## Police Modifier Bulletin

### SVE BULLETIN

### **2013MY and beyond Utility Police Interceptor Vehicle Modifications and Sealing**

2013MY and beyond Utility Interceptors

Figure 1

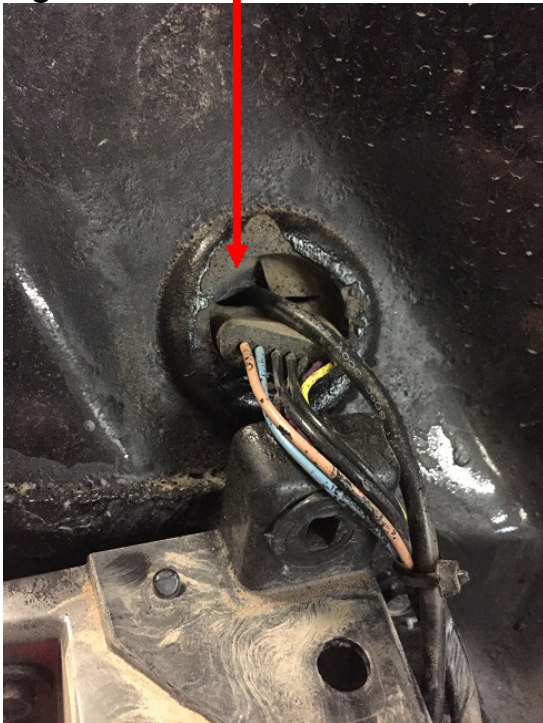
- Any holes in the rear of the vehicle must be sealed
- Wiring pass-throughs, through sheet metal and/or existing grommets behind the passenger side and driver side tail lamps must be fully sealed using Motorcraft Seam Sealer (TA-2-B)

### Passenger Side Tail Lamp not properly sealed

***Any and all holes created which are exposed directly or indirectly to outside air MUST BE completely sealed using Motorcraft Seam Sealer (TA-2-B).***

**Figure 3**

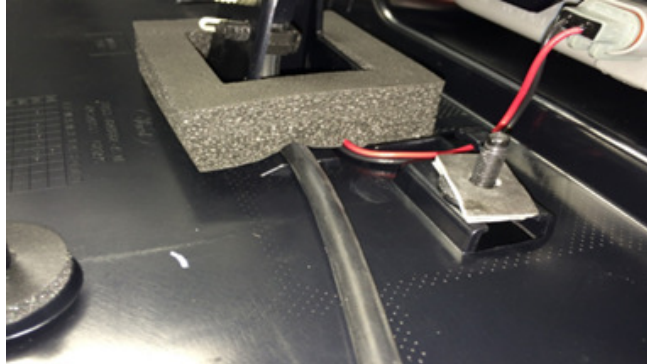
- Removal of the rear spoiler requires thorough sealing upon reinstallation.
- Inspect the foam tower seal and ensure that the wiring and washer line are properly routed and are not comprising the sealing interface (see Figure 3).
- Repair and/or re-seal as necessary using Motorcraft Seam Sealer (TA-2-B).
